# CITY PLANNING COMMISSION

APPLICATION: 1. Conditional Negative Declaration  
2. Special Permit to develop 232 apartment units within the Delta Point PUD

LOCATION: Southeast corner of Truxel Road and West El Camino Avenue

PROPOSAL: The applicant is requesting the necessary entitlements to develop 232 apartment units within the Delta Point North portion of the Delta Point PUD.

Exhibit D - Staff Proposed Site Plan

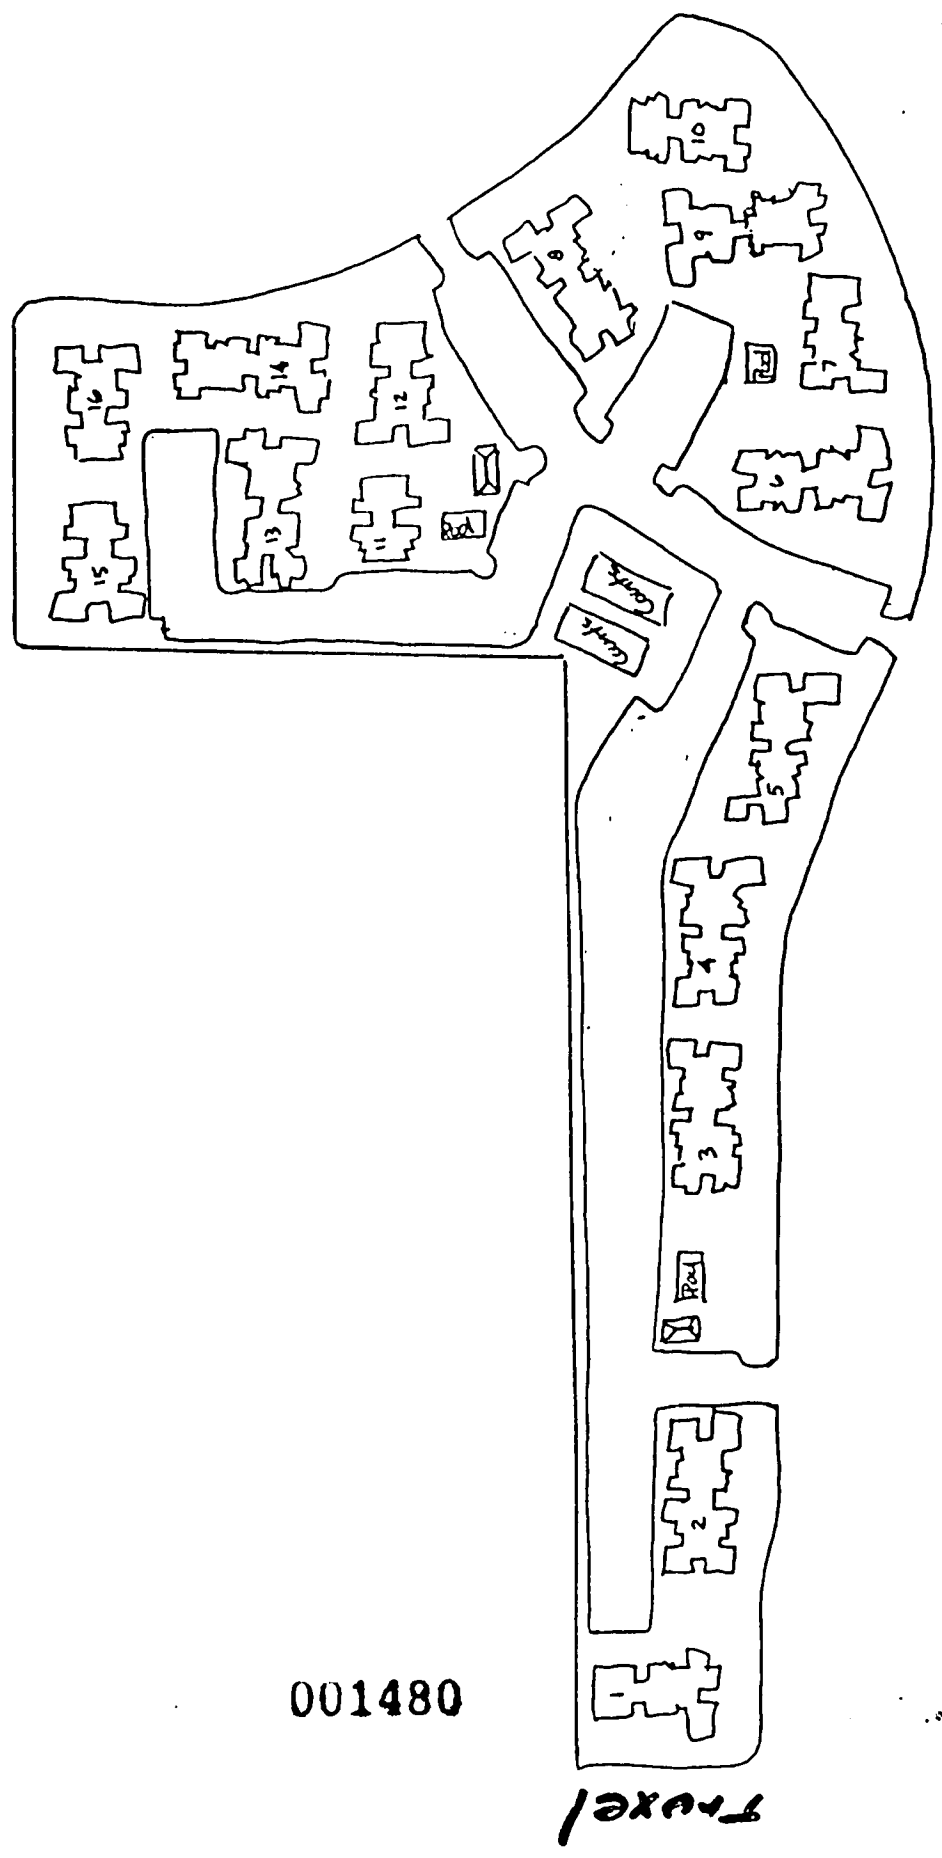
The site plan indicates a logical utilization of the site with the majority of the dwelling units located adjacent to the southern and eastern residential streets and parking located along the interior of the site adjacent to the future shopping center development. Four active recreational areas are dispersed throughout the site to provide for convenient access. The only detrimental aspects of the site plan is the lack of accessibility of on-site parking to the clusters 14 and 16, as well as clusters 7 and 10. Also, the large parking lot adjacent to the entrance/exit to Sand Castle Way needs to be further refined. Staff recommends the site plan be revised per Exhibit 'D' to provide for more accessible on-site parking and to eliminate the large parking lot.

- b. The site plan shall be revised in general conformance with staff's Exhibit 'D' prior to issuance of building permits;
  - c. The following improvements shall be installed and necessary studies submitted and approved by City Engineering prior to issuance of building permits:
